## HISTORIC DISTRICTS REVIEW BOARD FIELD TRIP

**MINUTES OF THE**  
**CITY OF SANTA FÉ**  
**HISTORIC DISTRICTS REVIEW BOARD**

**February 26, 2013**

Exhibit 1

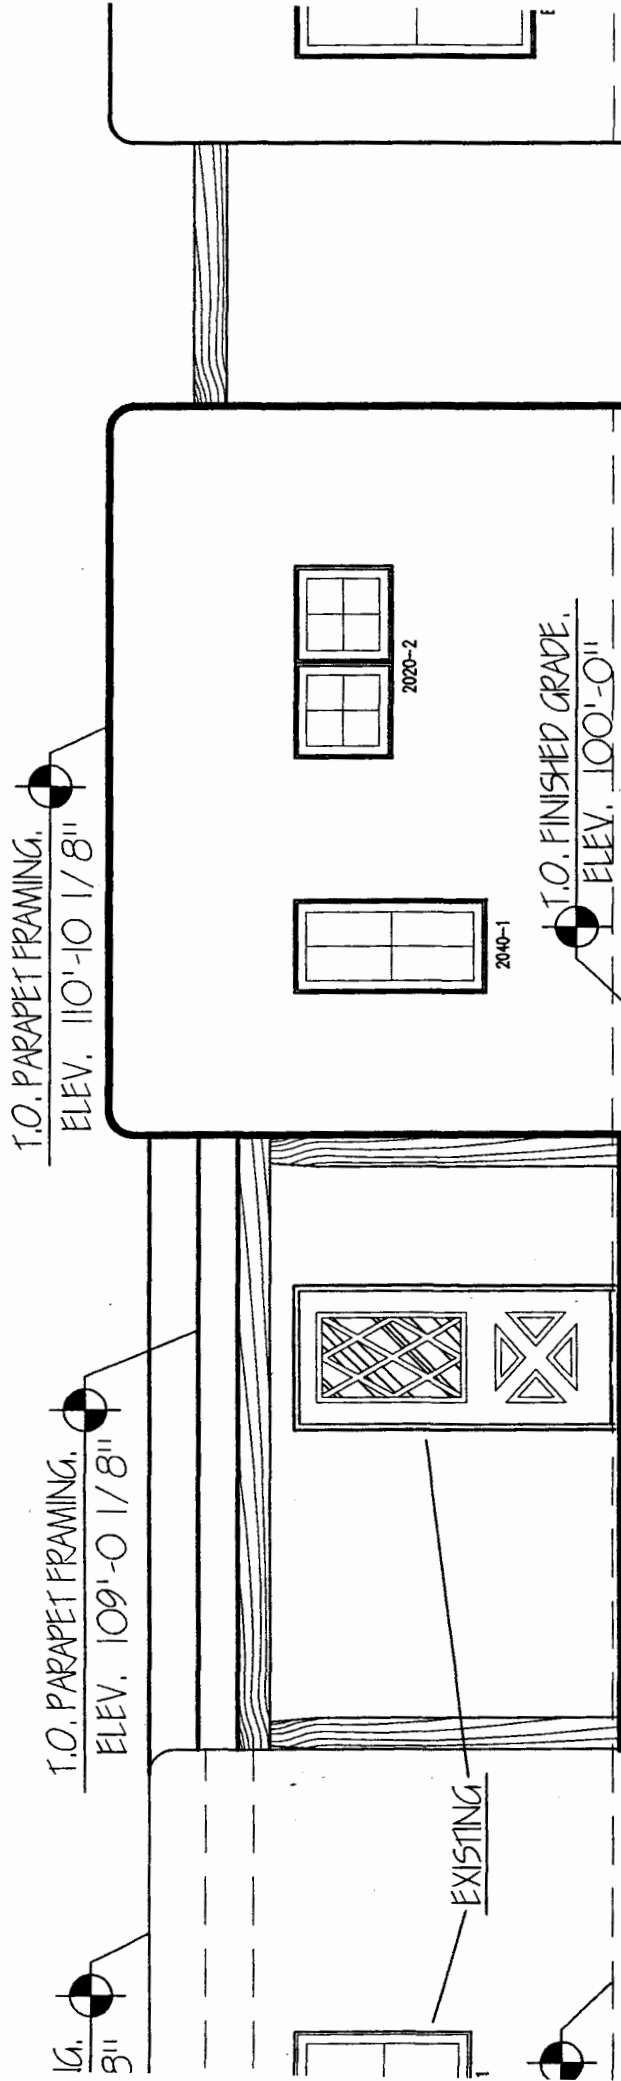
2. A 341 square foot addition will be constructed at the southeast corner of the residence to 11' high. The publicly-visible south elevation will have paired smaller windows and one larger window, of which the latter is closer than 3' to a corner and an exception has not been posted or requested. He handed out a revised drawing that would re locate the window to meet the 3 foot rule [attached to these minutes as Exhibit 1]

Staff recommends approval of this application as complying with Section 14-5.2(D)(9) General Design Standards, Height Pitch Scale and Massing and (E) Downtown & Eastside Historic District with the condition that the Board accept the revision shown in the applicant's handout.

**Ms. Rios moved to approve Case #H-12-028 per staff recommendations using the revised window location as presented by the applicant with the conditions that the applicant may use synthetic stucco; that on the zero lot line, two windows be eliminated and a skylight not visible by permitted and that exterior light fixtures be taken to staff for approval. Ms. Walker seconded the motion and it passed by unanimous voice vote.**
